Service Bulletin : XTM-0002

Some axles installed on the LG MAX and LG Mini, may have been torqued outside the axle manufacturer's specification. This issue has the potential for the axle's hardware to break or become loose from the chassis.

LG MAX & LG MINI MAX

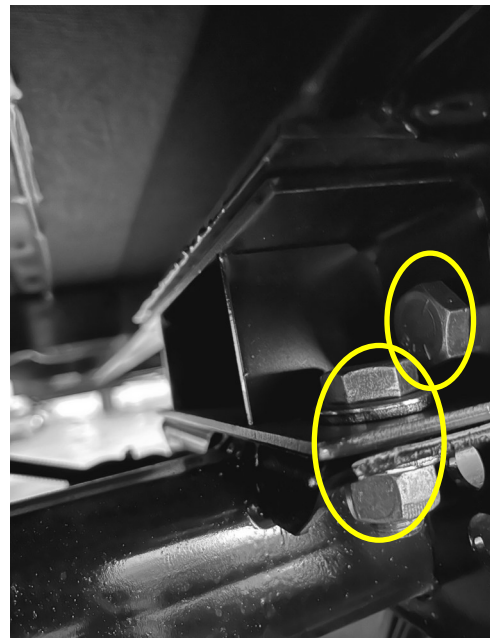
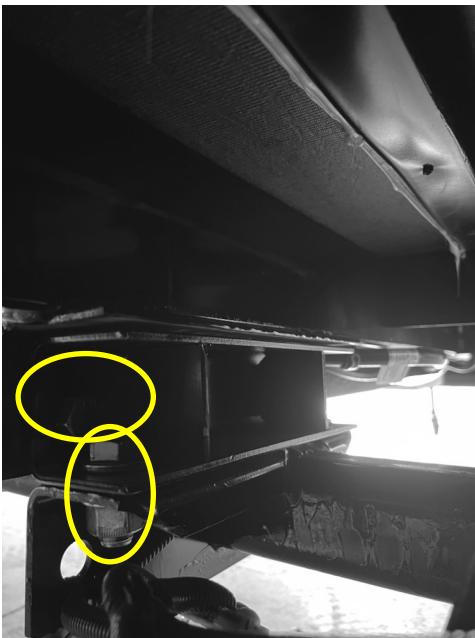
Hardware installed on the axle mounts may be torqued under specification.

Using a closed end wrench and torque wrench, tighten the 4 mounting bolts (per side) to the axle manufacturer's specification of 125—175ft.-lbs. (Shown Below)

Tighten the axle mounting hardware to the specified torque. 125 — 175 ft.-lbs.
